Beaver Valley Power Station, Unit Nos. 1 and 2
Docket No. 50-334, License No. DPR-66
Docket No. 50-412, License No. NPF-73
Davis-Besse Nuclear Power Station
Docket No. 50-346, License No. NPF-3
Perry Nuclear Power Plant
Docket No. 50-440, License No. NPF-58
FirstEnergy Nuclear Operating Company's (FENOC's) Second Six-Month Status Report
in Response to March 12, 2012 Commission Order Modifying Licenses with Regard to
Reliable Spent Fuel Pool Instrumentation (Order Number EA-12-051)
(TAC Nos. MF0799, MF0800, MF0960, and MF0802)

Beaver Valley Power Station Second Six-Month Status Report for the Implementation of
Order EA-12-051, Order Modifying Licenses with Regard to
Reliable Spent Fuel Pool Instrumentation
Page 1 of 7

Response to Request for Additional Information for
Beaver Valley Power Station
Page 1 of 13

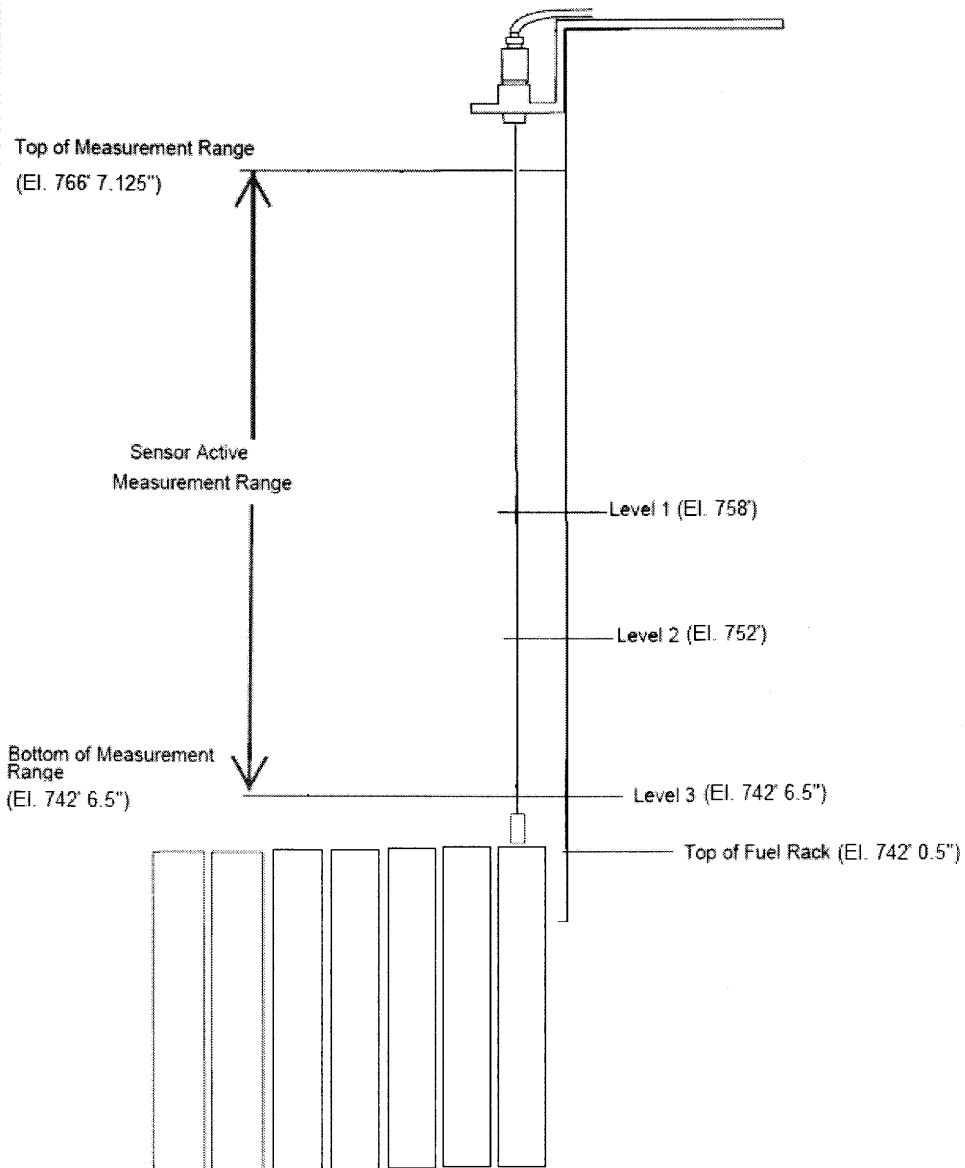
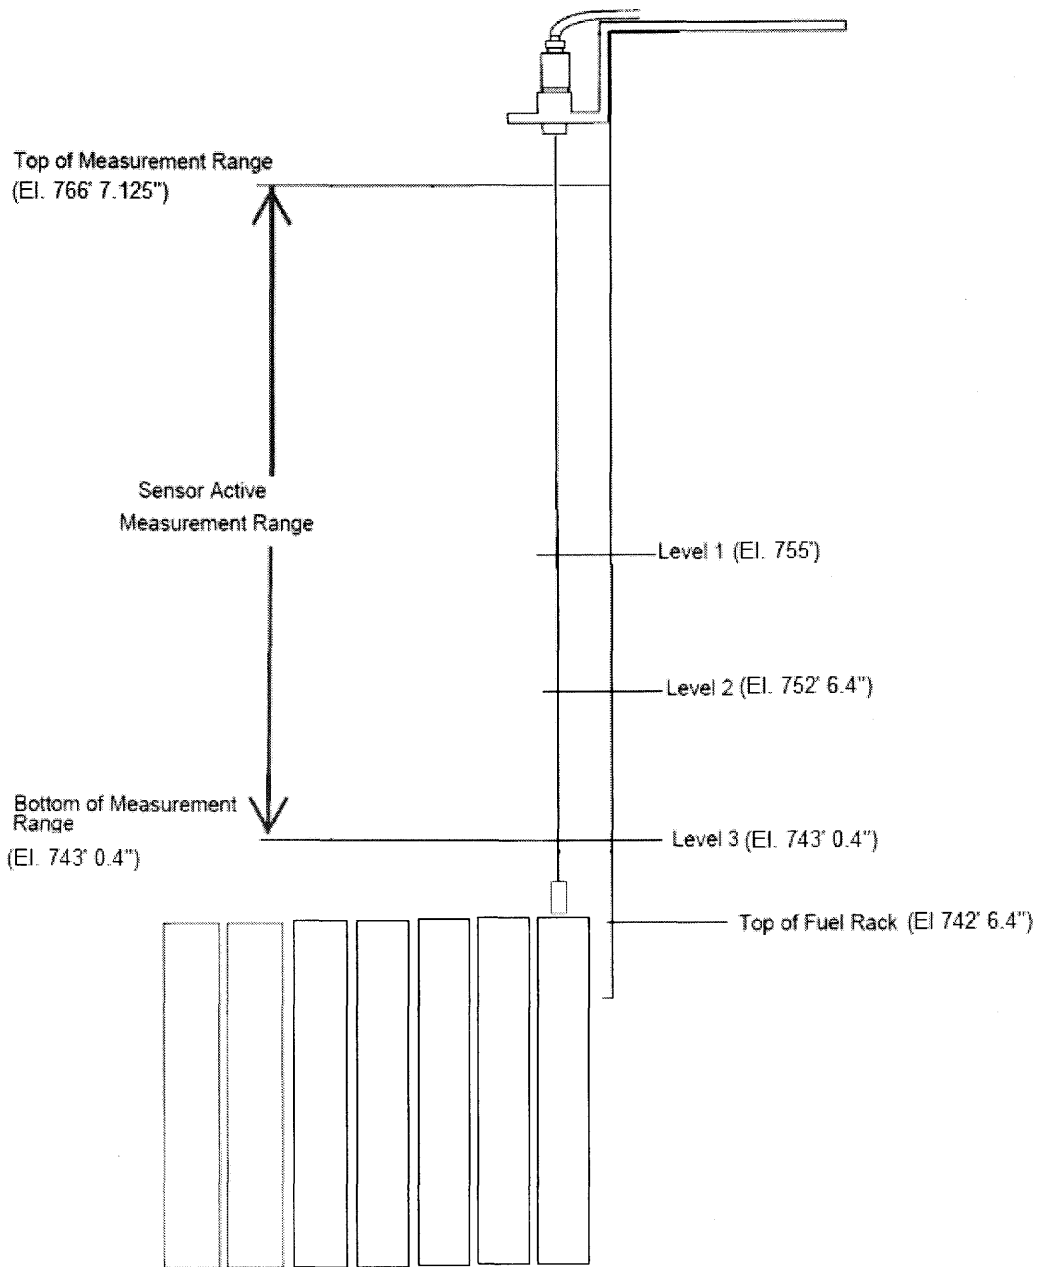
Please provide a clearly labeled sketch depicting the elevation view of the proposed typical mounting arrangement for the portions of the instrument channel consisting of permanent measurement channel equipment (e.g., fixed level sensors and/or stilling wells, and mounting brackets). Indicate on this sketch the datum values representing Level 1, Level 2, and Level 3, as well as the top of the fuel racks. Indicate on this sketch the portion of the level sensor measurement range that is sensitive to measurement of the fuel pool level, with respect to the Level 1, Level 2, and Level 3, datum points.

The following two sketches are provided. The first sketch depicts the elevation view for Unit 1. The second sketch depicts the elevation view for Unit 2.

Unit 1

Unit 2

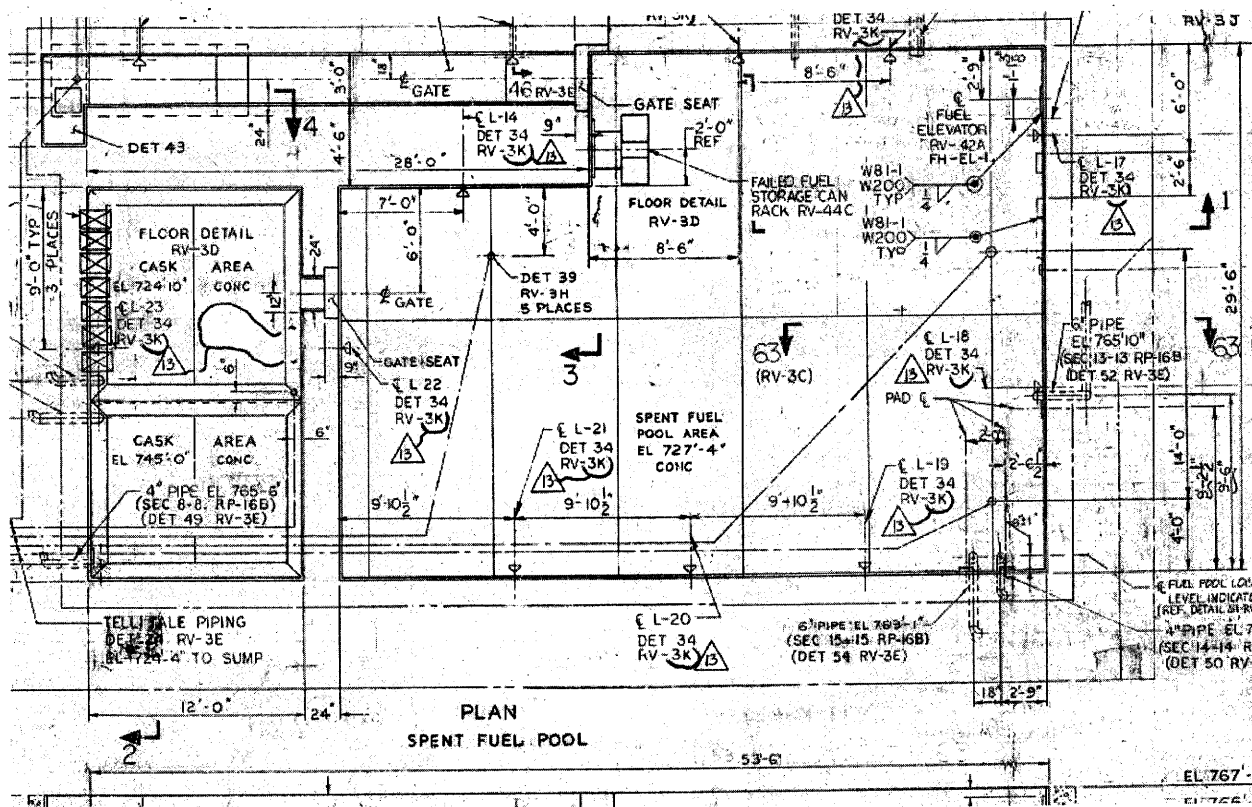
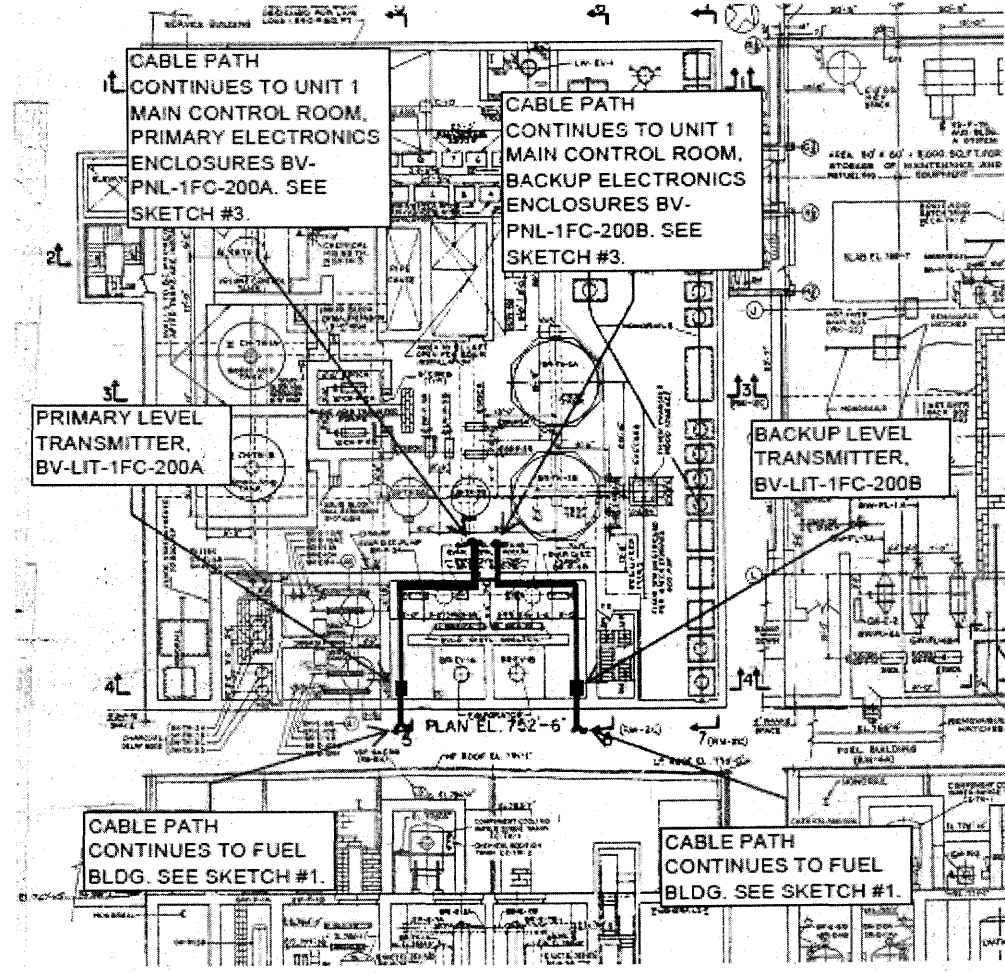
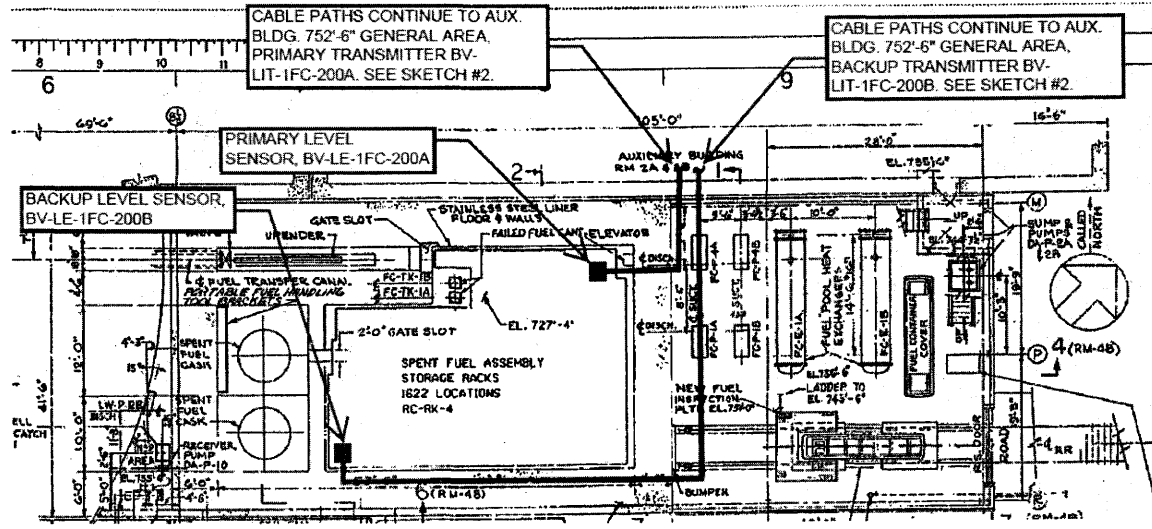
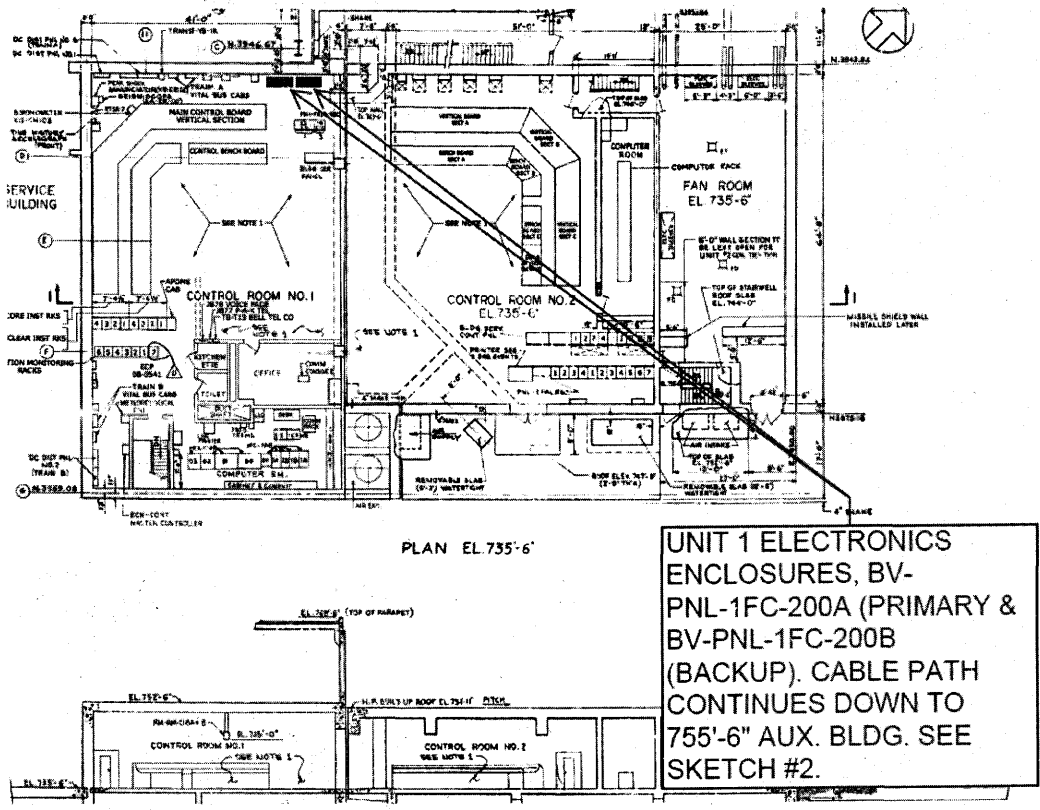
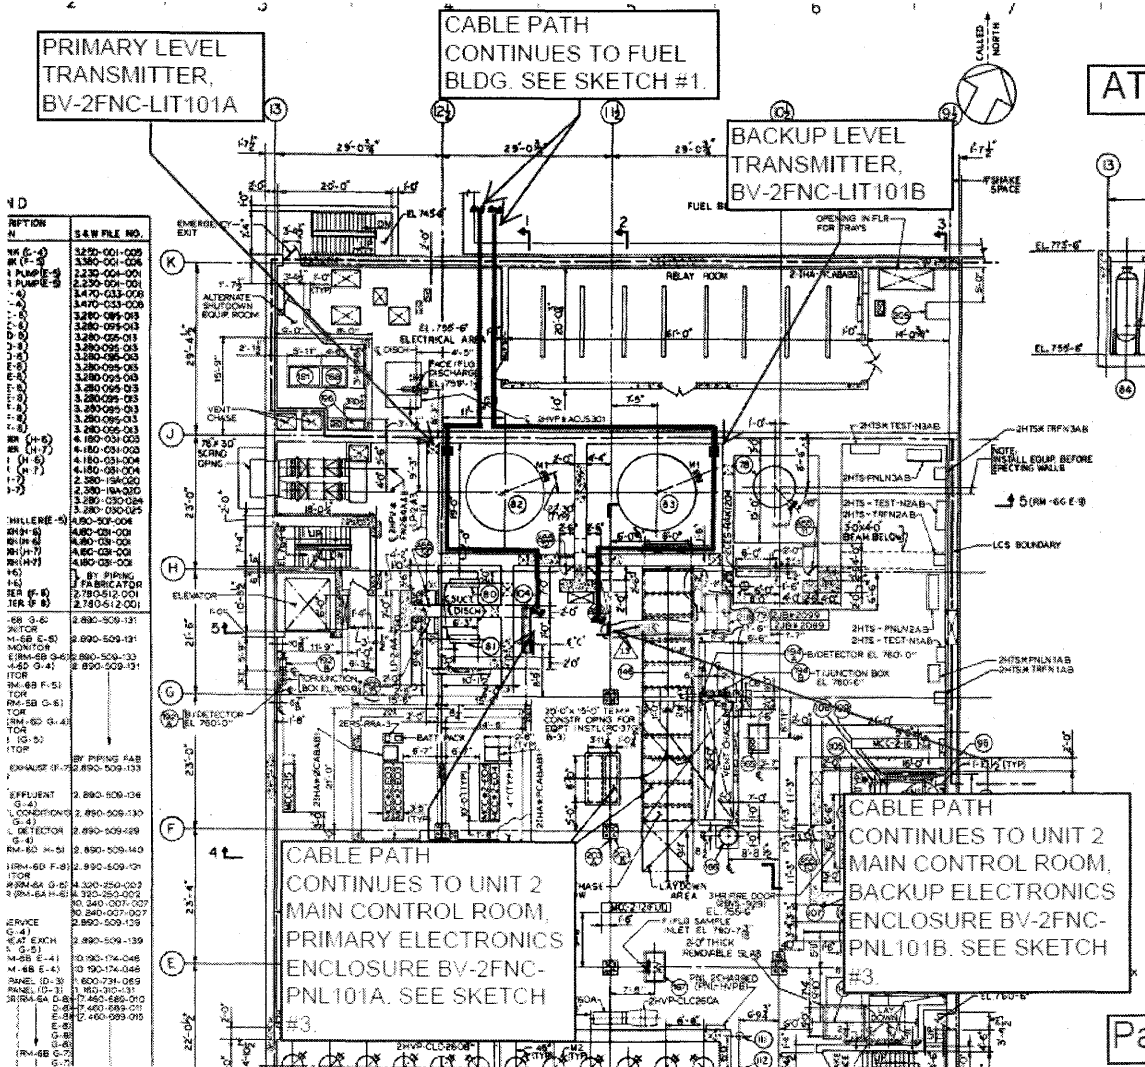
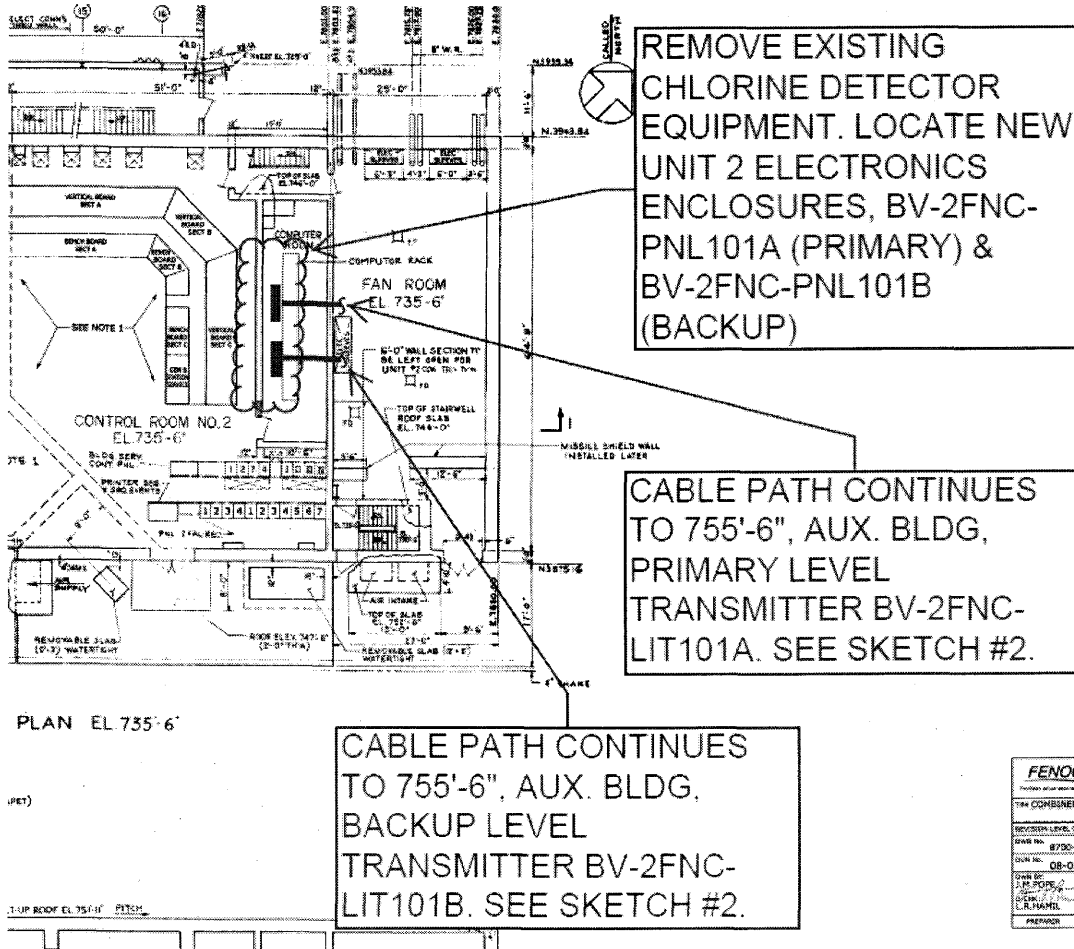
Please provide a clearly labeled sketch or marked-up plant drawing of the plan view of the SFP area, depicting the SFP inside dimensions, the planned locations/placement of the primary and backup SFP level sensor, and the proposed routing of the cables that will extend from these sensors toward the location of the read-out/display device.

Below are excerpts from plant drawings, being used as sketches, that depict the preliminary design and locations of the two permanently mounted level probes within the SFP area and the cable routing to locate the electronics to a non-harsh environment outside the SFP area. These sketches are excerpts from the 30 percent design change package and include references to other sketches that are not included for this response.

The level transmitter electronics for Unit 1 will be located in the auxiliary building El. 755' 6", which is separated from the SFP area by one floor. The level transmitters located in the auxiliary building have a local display, although the credited display units will be located in the main control room.

The inner dimensions of the Unit 1 Fuel Pool are 39' 6" x 29' 6".

The level transmitter electronics for Unit 2 will be located in the auxiliary building El. 755' 6", which is separated from the SFP area by one floor. The level transmitters located in the auxiliary building have a local display, although the credited display units will be located in the main control room.

The inner dimensions of the Unit 2 Fuel Pool are 39' 4 5/8" x 29' 6".
